Development Permit Panel

**Wednesday, September 11, 2019
3:30 p.m.**

1. DEVELOPMENT PERMIT 18-829140
(REDMS No. 6144436)

APPLICANT: PLLR 228 Holdings

SHEET **A1.05**

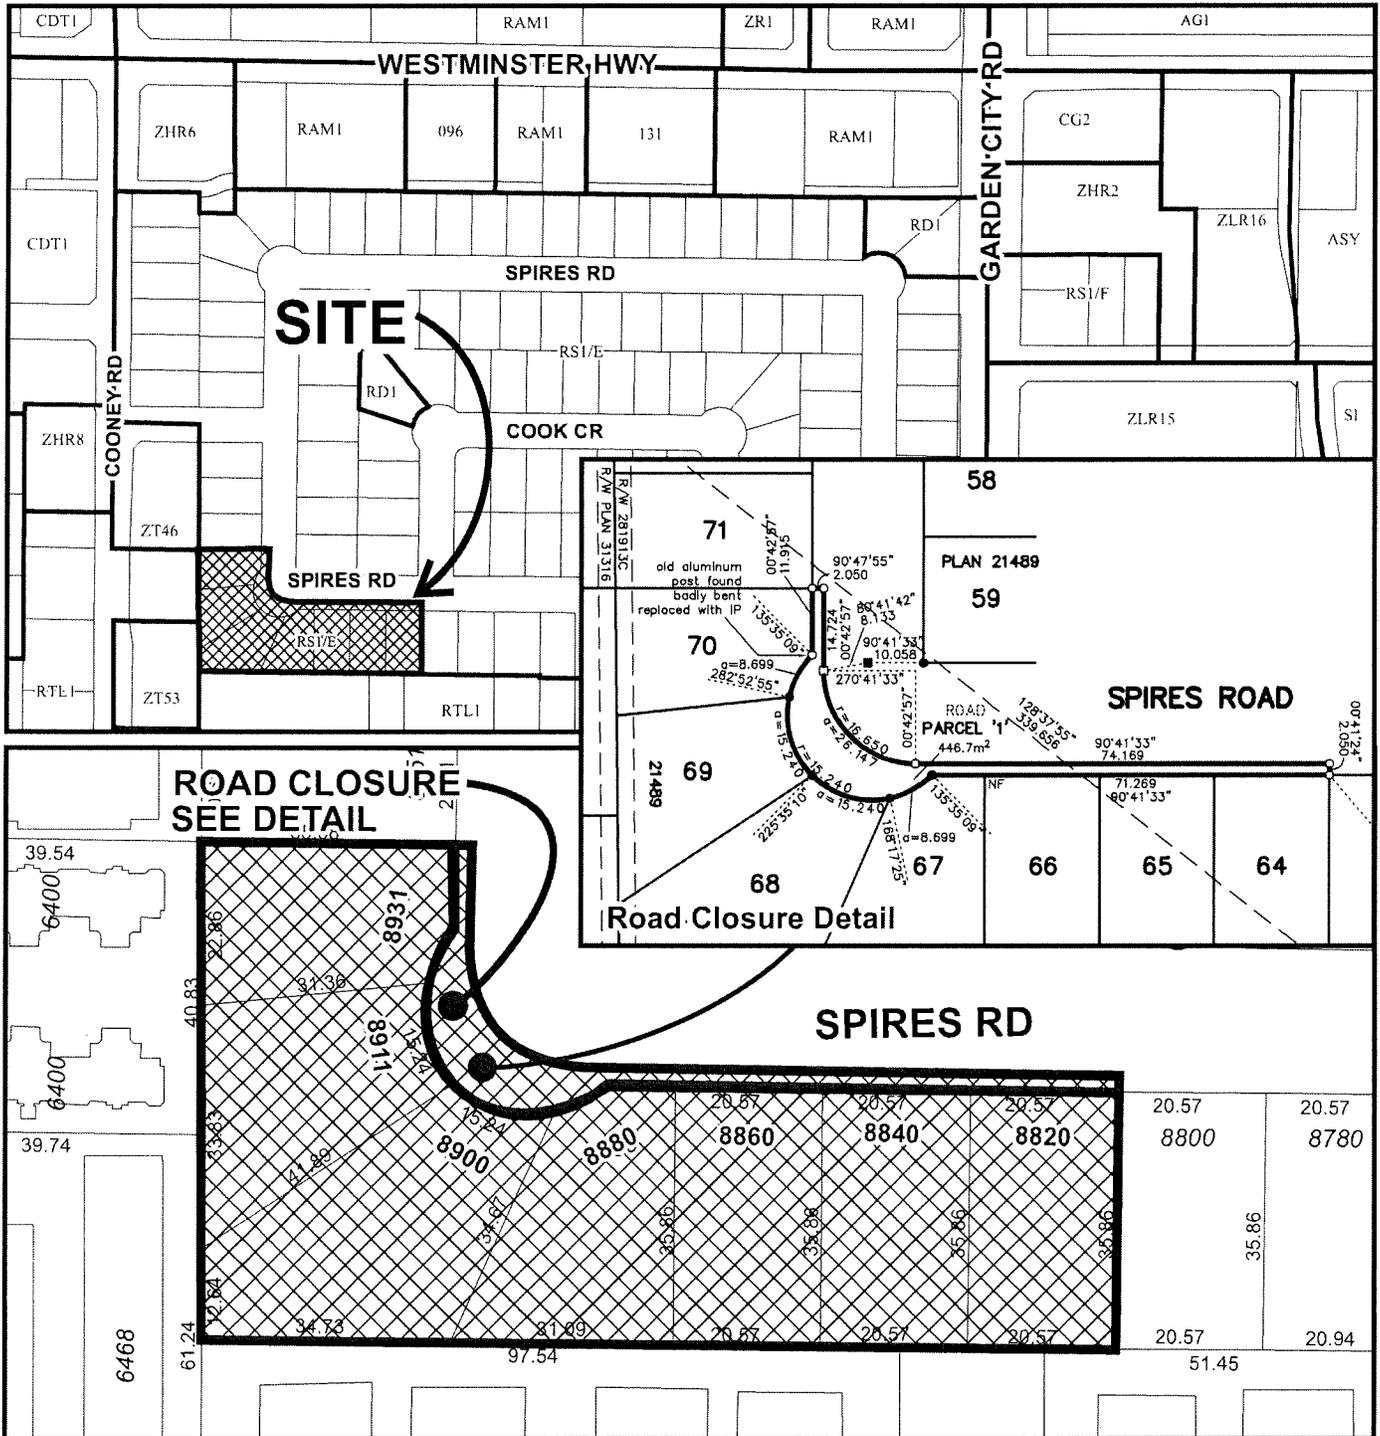
- accessible units open up to a common parkade; however, no pressurized vestibules are provided in the plans; applicant needs to review BC Building Code requirement for the provision of vestibules; staircases could be pressurized for units facing south;

Pressurized vestibules are proposed in all units, including the ground level units. Refer to A1.05 Ground Level Plan & Building 1/3/8 Plans.

SHEET A1.14

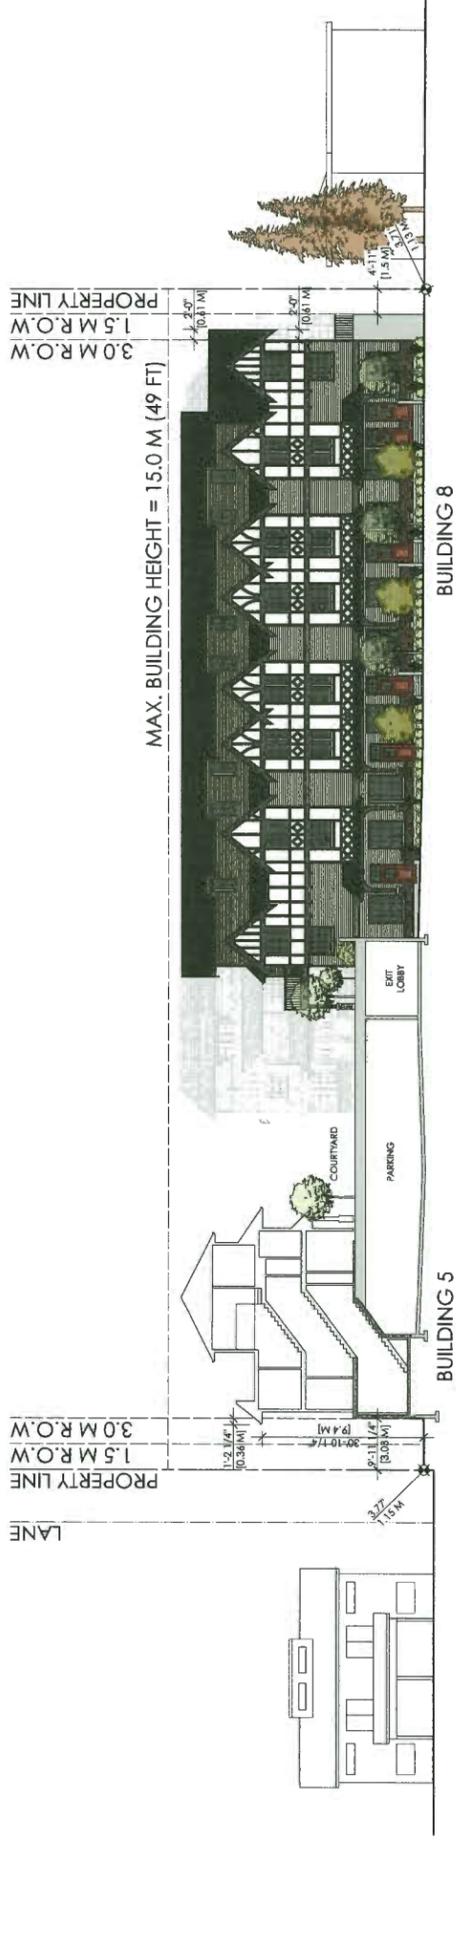
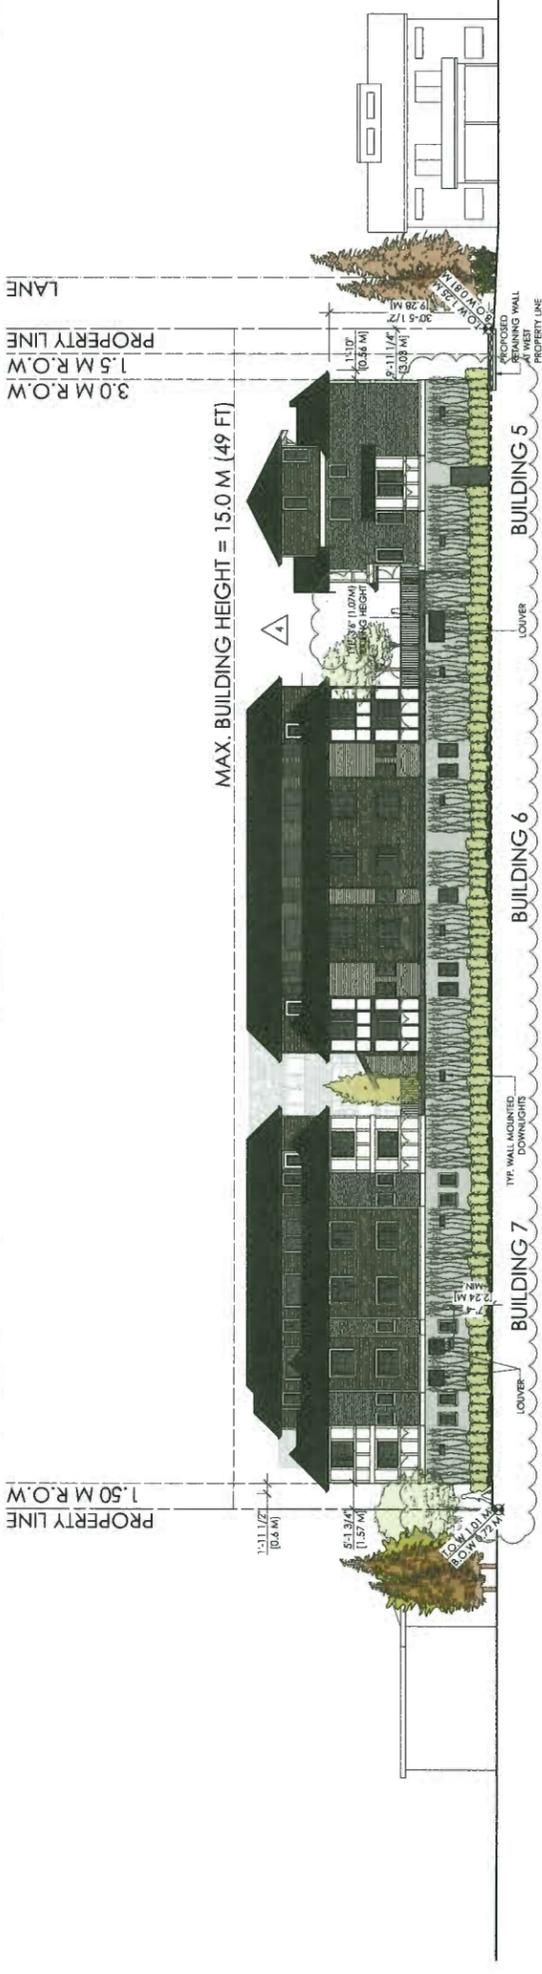
- appreciate that the applicant is considering to integrate public art into the project at this early stage;
- the building facade adjacent to the pedestrian walkways along the west and south property lines of the subject site could be visually broken down to pedestrian scale by introducing different textures and patterns on the building face; would enhance the pedestrian experience while planting along the pedestrian walkways is still growing;

Cable vines have been added to all exposed concrete walls to soften building edges. Refer to A1.13-A1.15 Streetscapes.

SCALE 3/16" = 1'-0"
 SHEET **A1.11**
 MARCH 2017

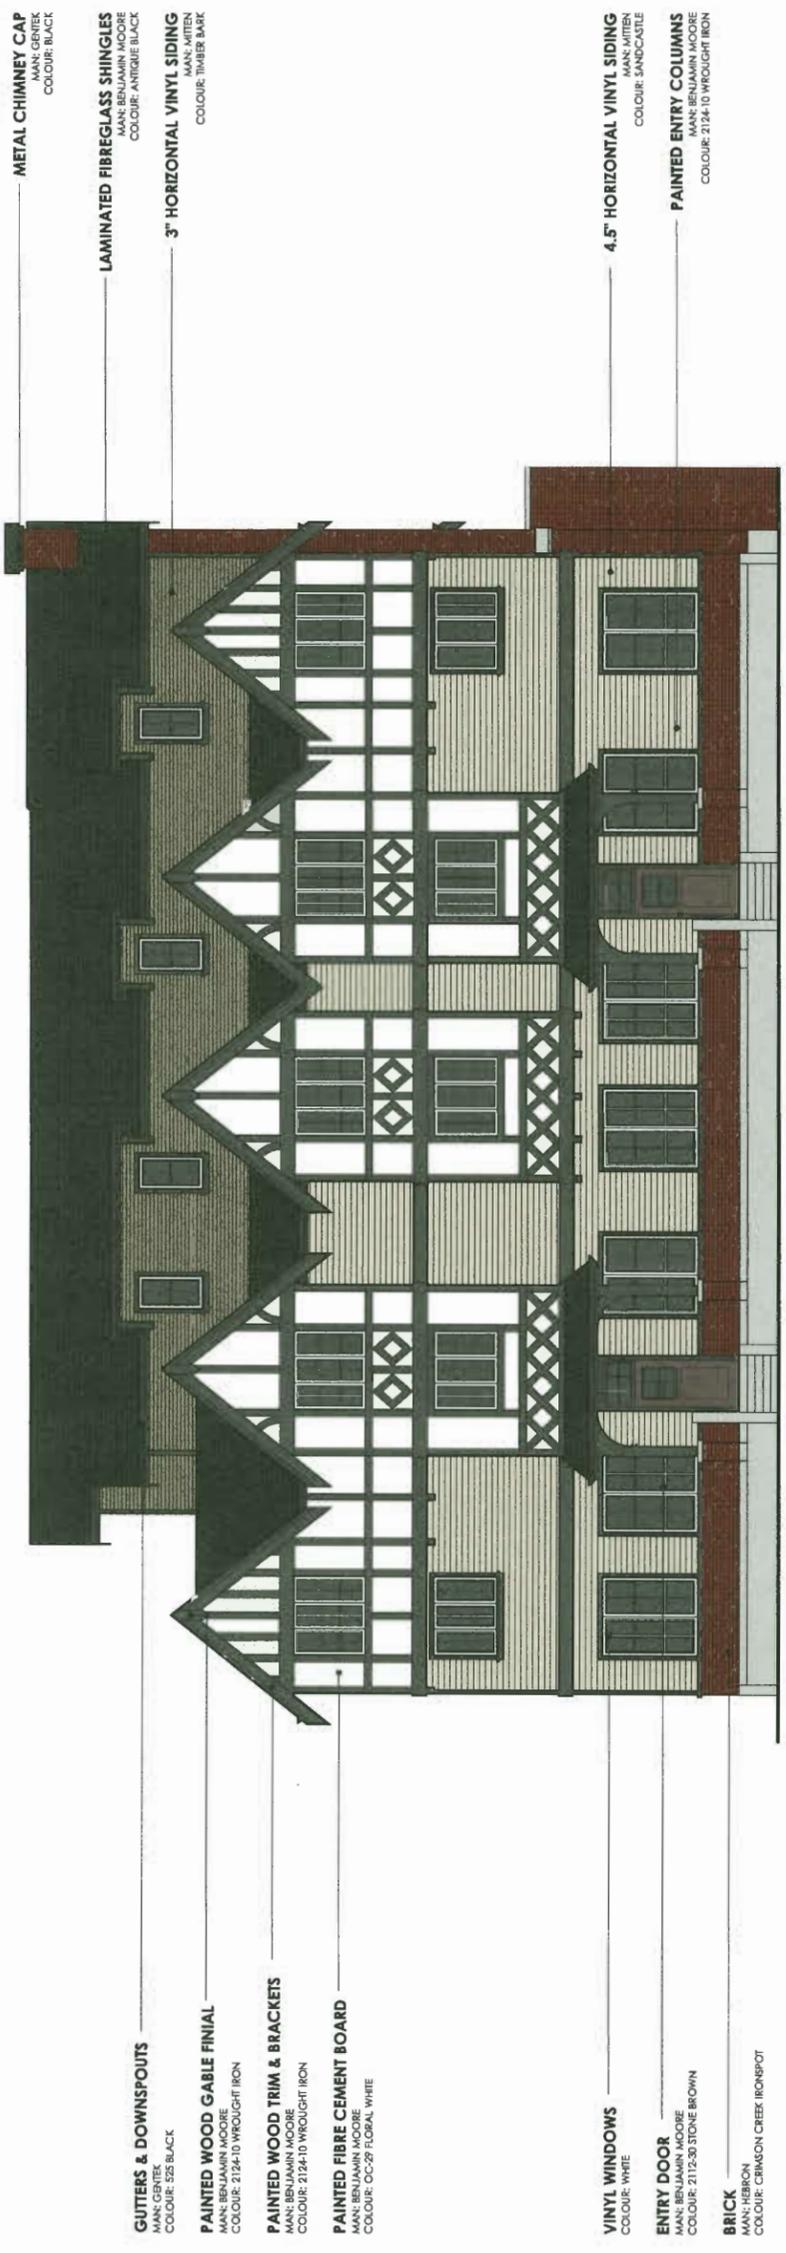
- appreciate the high level of quality and clarity of the drawings; however, the landscape drawings are not clear; difficult to understand where the landscape design is going with the landscape drawings provided by the applicant;
- the two proposed colour schemes are very similar; consider more variation to the two colour schemes to provide more variety to units;

Similar colour schemes are proposed to ensure cohesiveness in the development. The colour of the fibre cement board has been revised to an off-white colour in colour scheme A to provide more differentiation between the colour schemes. The Tudor trims remain the same colour for both schemes to tie the project together. Refer to A.11/A1.12 Colour Scheme A/B.
